Version history	PRODUCT GRAPHICS DOCUMENT	Scale:100% Unit: mm

Project: Cleer SPACE - DARK GREY

Version	Summary of updates	Approved for use by	Date	Version	Summary of updates	Approved for use by	Date
0.1	First draft	Adil	30 OCT 2018				
0.2	Logo and glass panel colour update	Kenneth Lam	14 DEC 2018

C Touch panel graphics

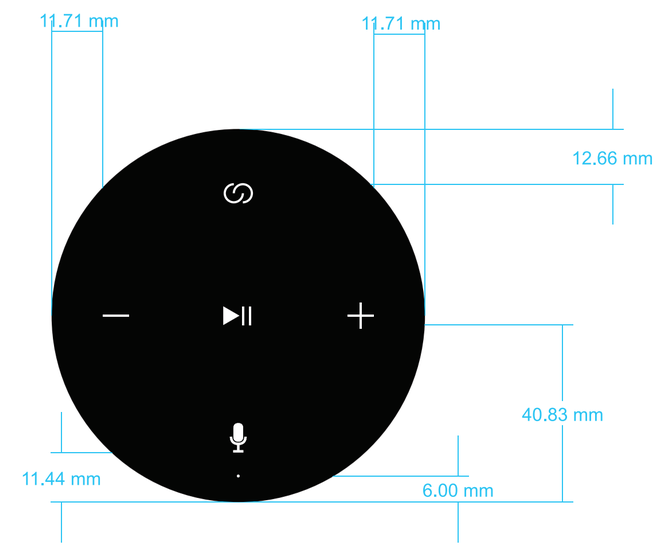
PART	COLOUR	TECHNIQUE	CHANGES / REMARKS	VER
A Compliance info	Pantone Cool gray 10C	Pad Printing	- -	0.1
B Bluetooth logo	Material color	In-Mold Engraving/ Depth - 0.25 mm, Finish : matte	- -	0.1
C Touch panel graphics	Pantone 432 C	Screen printing	The color is printed on the underside of the touch panel; colour changed to PMS 432 C	0.2
D Cleer logo	Pantone Cool Grey 5 C	Screen printing	Changed from engraving to screen printing	0.2
